**STAFF REPORT - DESIGN REVIEW E  
FINDINGS AND RECOMMENDATION**

FILE NUMBER: DRE/TR 19-26000014

PROPOSAL: Type III Design Review E for the construction of one multifamily building with three stories and associated parking and site improvements, and Type II Tree Removal for the removal of 31 regulated trees.

**13** TRASH ROOM PLAN  
**NOTE:**  
STANDARD DUMPSTER SIZES SHOWN PER  
CITY OF GRESHAM RECYCLING & WASTE

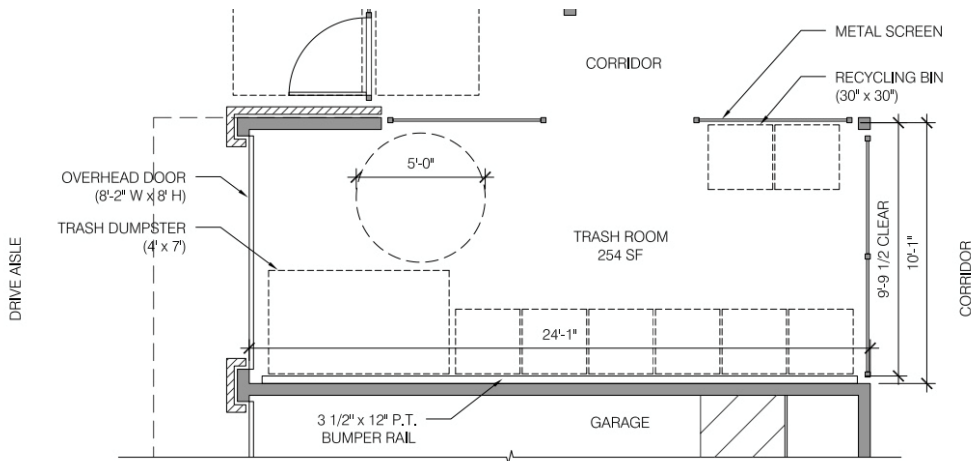
The proposed garbage and recycling configuration provide insufficient access and maneuverability. The revised enclosure configuration shown below (Detail 13) is approved. There must be a smooth transition from the garbage enclosure to the parking lot.

6. Solid Waste and Recycling:
- a. Provide plans demonstrating a smooth transition from the garbage room to the parking lot.
  - b. Provide revised site plans, floor plans, details and elevations demonstrating the revised trash and recycling room design shown in Detail 13, herein. The design is subject to Manager Approval.

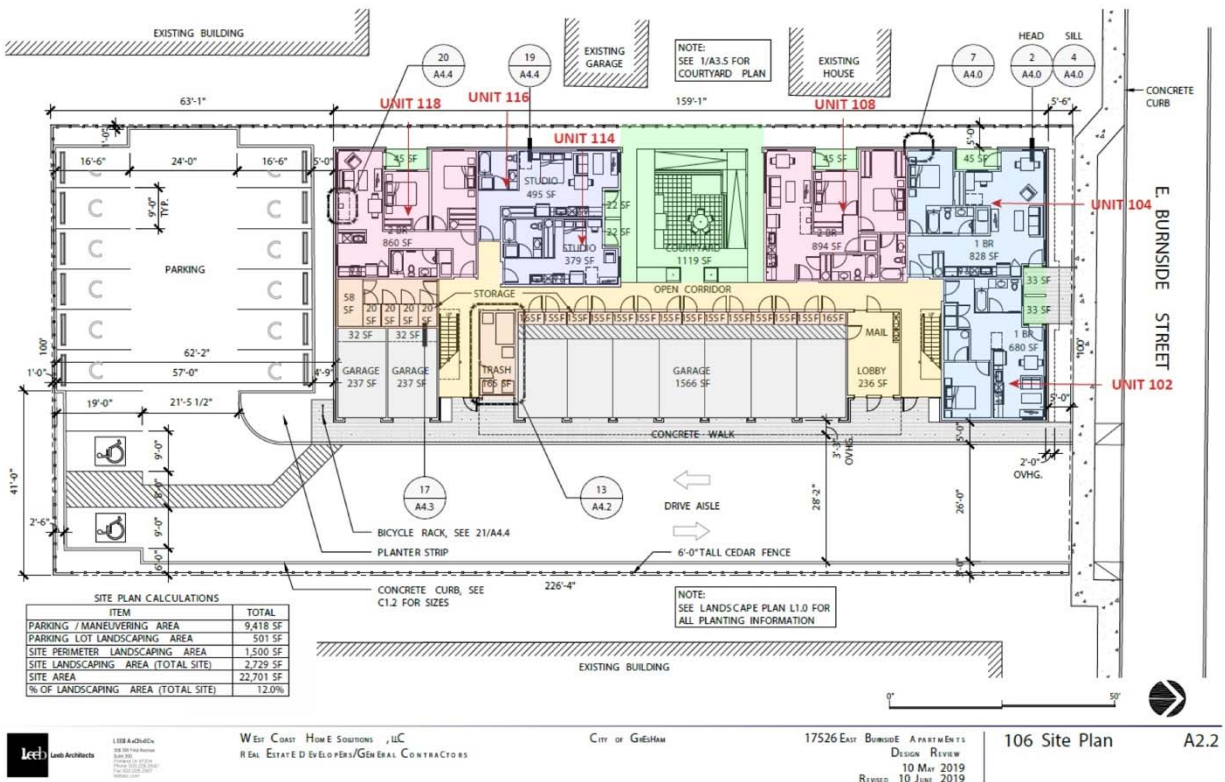
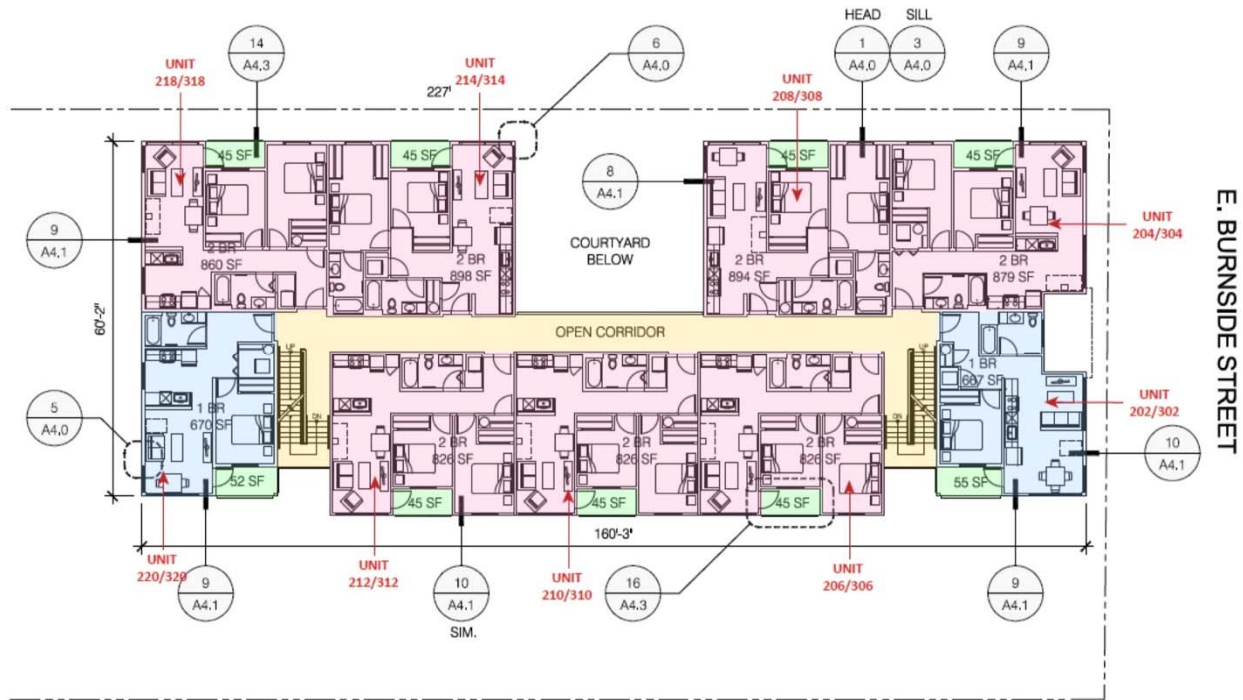
The proposal is for a three-story apartment building with a total of 24 units. Each apartment will be assigned a unique apartment number indicating its location in the building. Posting of the addresses on the building is regulated by the Gresham Emergency Services Department. Please refer to the Fire Department.

- Update the address on the site plan to read: 17528 E BURNSIDE STREET, PORTLAND, OR 97233
- Remove all periods in street names. For instance, E. BURNSIDE STREET should appear as E BURNSIDE STREET

East Burnside Apartments  
 17528 E Burnside St.  
 Portland OR 97233
